# SiliconSage Centerville Mixed Use Project

## Environmental Impact Report FINAL

37358-37494 Fremont Boulevard, 3804 and 376880 through 3820 Peralta Avenue,  
and 37417 Jason Way, Fremont, CA

City of Fremont

In response to Comment 4-1, on page 2-20 of the Draft EIR, under Section 2.5.1, Proposed Project, add a new Figure 2-10, titled: Proposed Boundary Adjustments in vicinity of Jason Way, as contained on the following page.

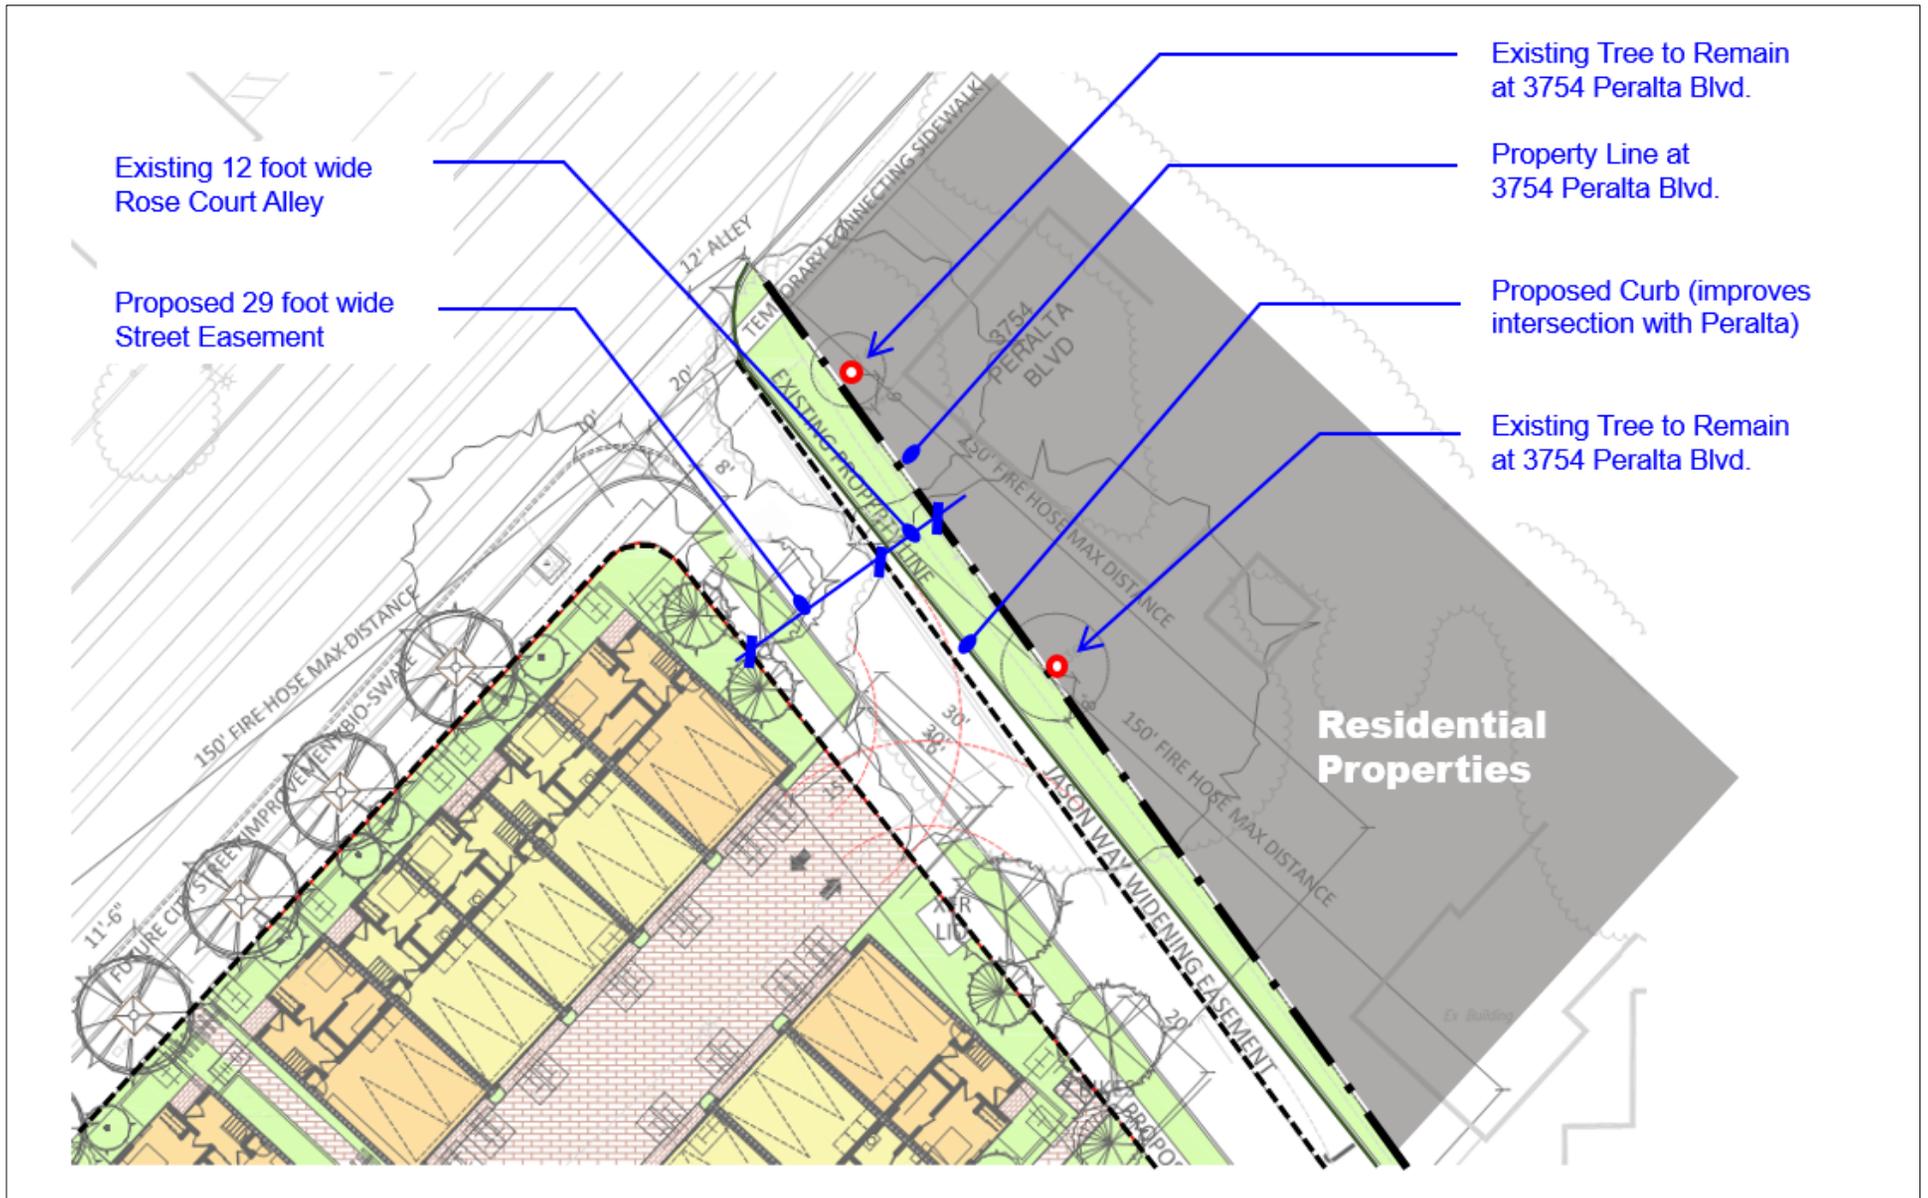
- 1- Note.. We have not signed a Right of way for our property. I4-1
- 2- Where will Jason way touch/blend with our property? Exactly. I4-2
- 3- How will the access from the townhouses onto Jason way effect our property ? I see driveways that I am not comfortable with. I4-3

- 4-1 The commenter notes that a right-of-way (ROW) agreement for their property (3754 Peralta Boulevard) has not been signed.

**Response:** The proposed Tentative Tract Map for the project shows that a ROW or boundary adjustment of the 3754 Peralta Boulevard parcel is not required for the proposed project – the property line between the 3754 Peralta Boulevard parcel and the existing Jason Way ROW is not proposed to be changed. The proposed widening of Jason Way would occur on the southwestern side and require dedication of a portion of parcel APN 501-1475-050-02 (part of the project site) as public ROW. A figure showing the proposed boundary adjustments along Jason Way is included in this Final EIR in response to this comment (see Section 4, below).
